RESOLUTION NO. R 2262

A RESOLUTION OF THE CITY OF KIRKLAND APPROVING AMENDMENT AND MODIFICATION OF SUBSTANTIAL DEVELOPMENT PERMIT PREVIOUSLY AUTHORIZED BY RESOLUTION NO. R2252 AND AUTHORIZING TRANSFER OF SAID PERMIT FROM DEAN CHAUSSEE TO S & H BUILDERS COMPANY.

MOSS BAY APARTMENTS
(Pleasant Bay Apartments)
SDP-74-8(H)
Revised Site Plan R-2262

SITE PLAN (REVISED)

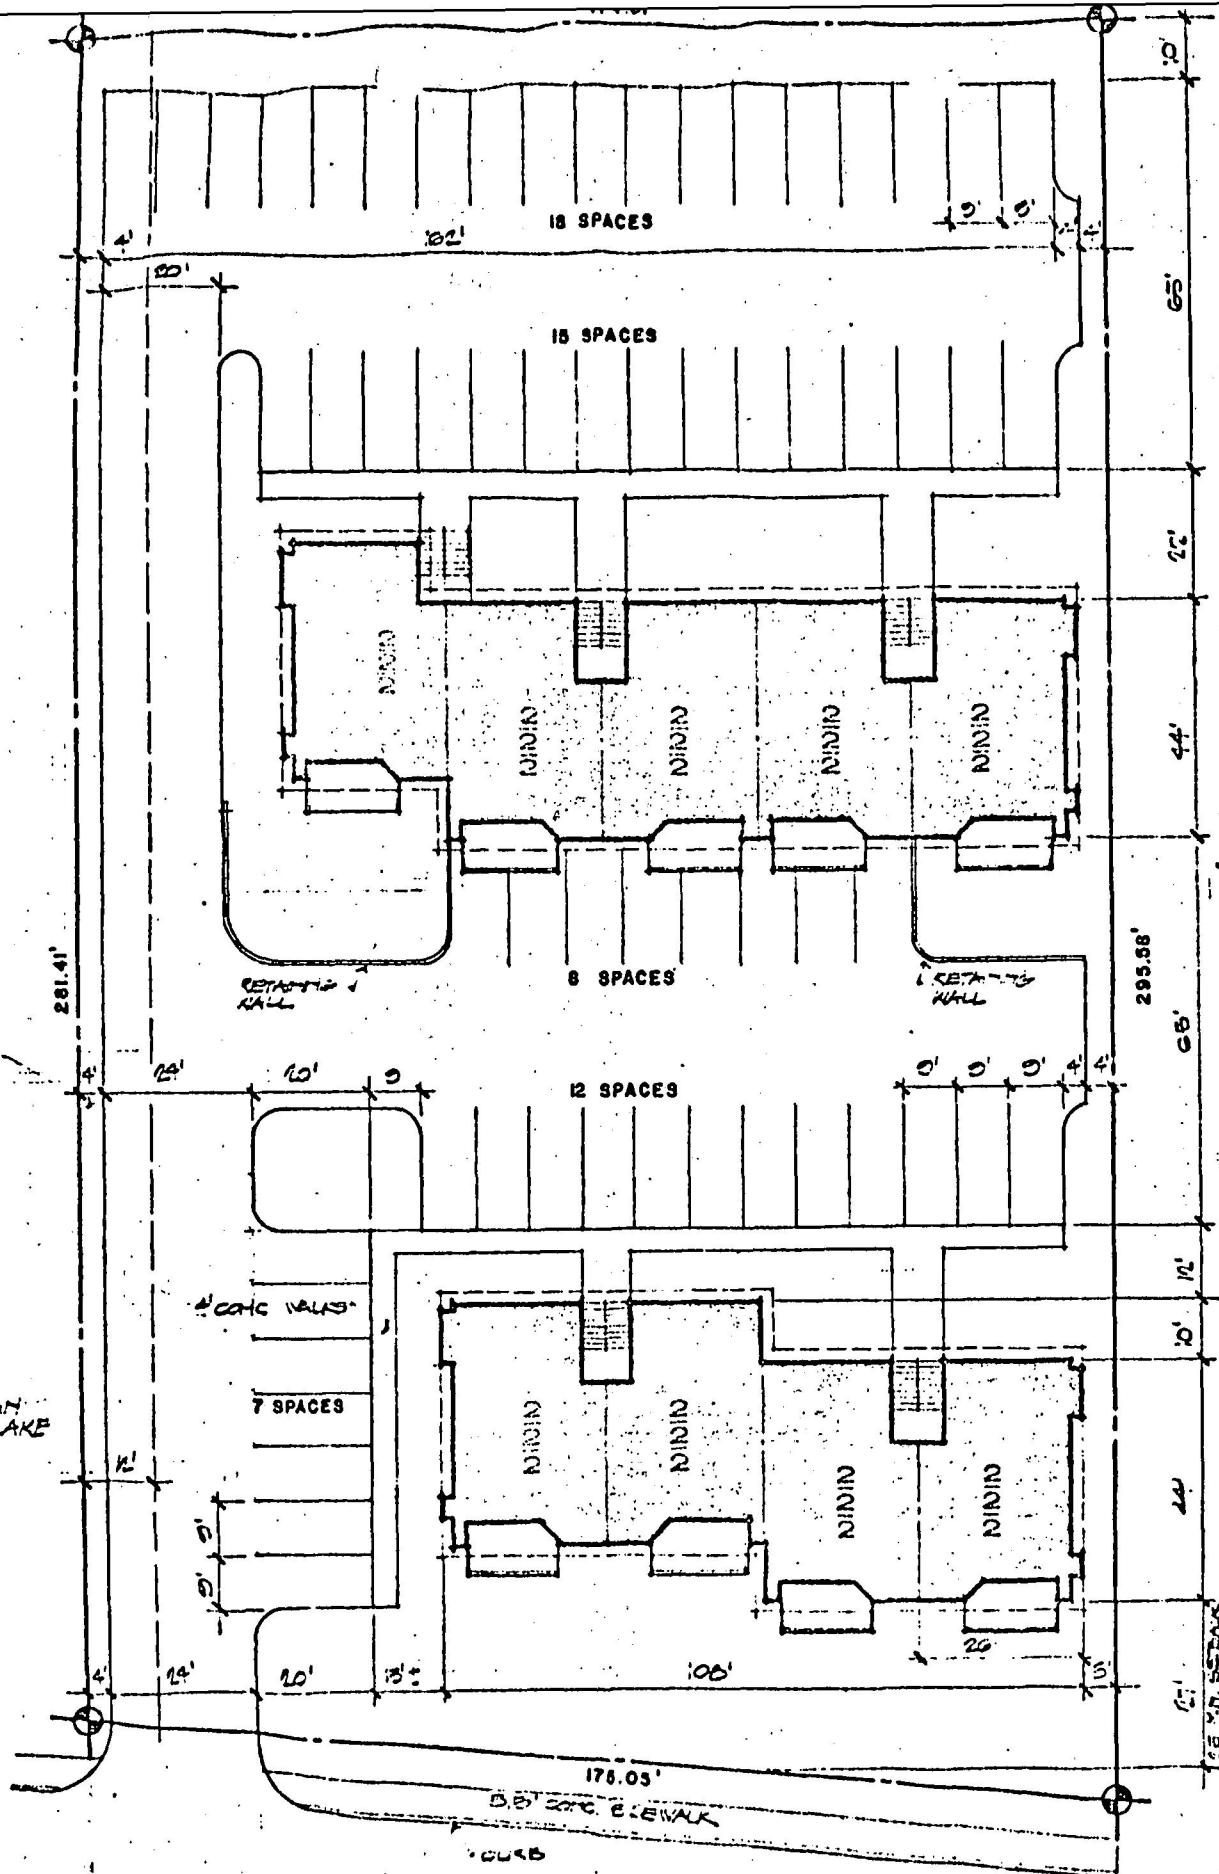
WHEREAS, in the course of said transfer it was discovered by survey that the north-south dimension of said property is approximately six and one-half feet less than appeared on the original application, and that as a result thereof, the area under appropriate zoning can accommodate 27 units, rather than 30 units, and

WHEREAS, S & H Builders Company has applied to the City for a modification and amendment of the Substantial Development Permit to reduce the total number of apartment units all as appears on Exhibit A attached to the original of this Resolution, and

Section 1. The Substantial Development Permit heretofore issued as Permit No. SDP-74-8(h) pursuant to Resolution No. R2252 adopted May 20, 1974 is hereby modified and amended in accordance with Exhibit A (amended site plan) and Exhibit B (corrected legal description and survey) attached to the
